**STAFF REPORT  
WEST ALLIS PLAN COMMISSION  
Wednesday, August 28, 2019  
6:00 PM**

4. **Site, Landscape and Architectural Plans for proposed building renovations to the existing building located at 1959 S. 54 St., submitted by Jerman Ruiz and Arturo Guzman of Ideal Express and Luis Barbosa, BMR Design Group, Architect (Tax Key No. 474-0036-001)**

1 New East Elevation (Front)  
 A-4 Scale: 1/8" = 1'-0"

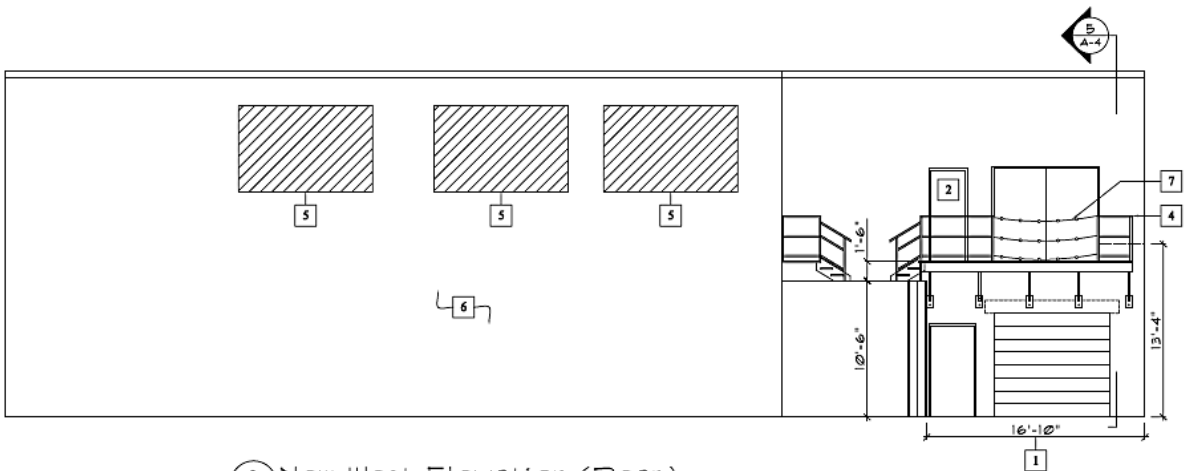
- Revised plans being provided to modify the scope of work to include more windows into the project. As proposed, the applicant's plans show most of the window openings (currently covered with a plastic material) being infilled with cement block and painted to match the building.
- Submittal of a schedule for implementation of the proposed and recommended site, landscaping and architectural improvements.
- Applying for an occupancy permit and a signage permit.

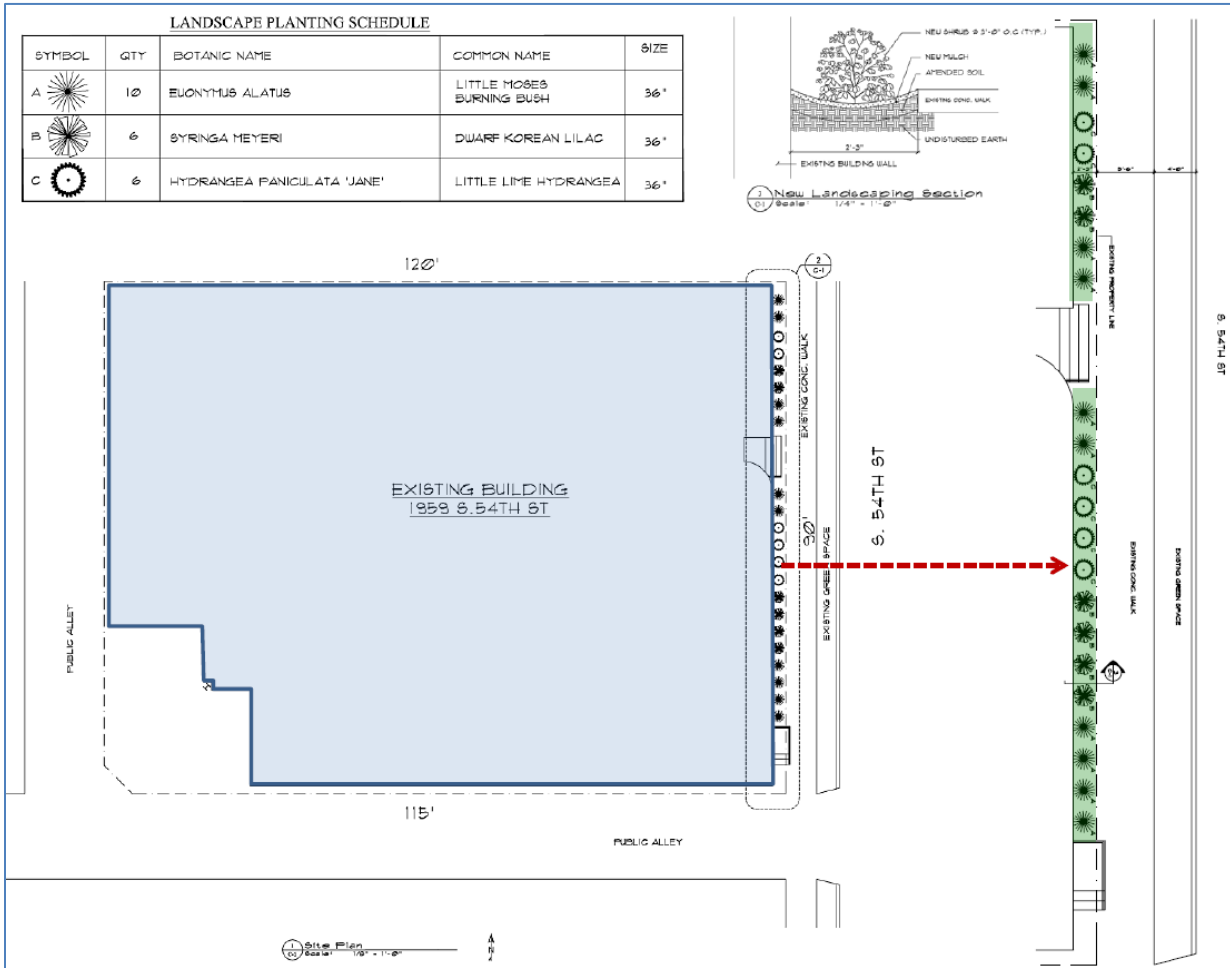
- Staff is recommending that the damaged staircase and railing on the SE corner of the site be repaired or replaced.
- A refuse location is not shown on the plan. If the refuse area is to be kept within the building it should be noted on the plans. If located outside the building, a refuse enclosure and screening details are to be provided on plans.
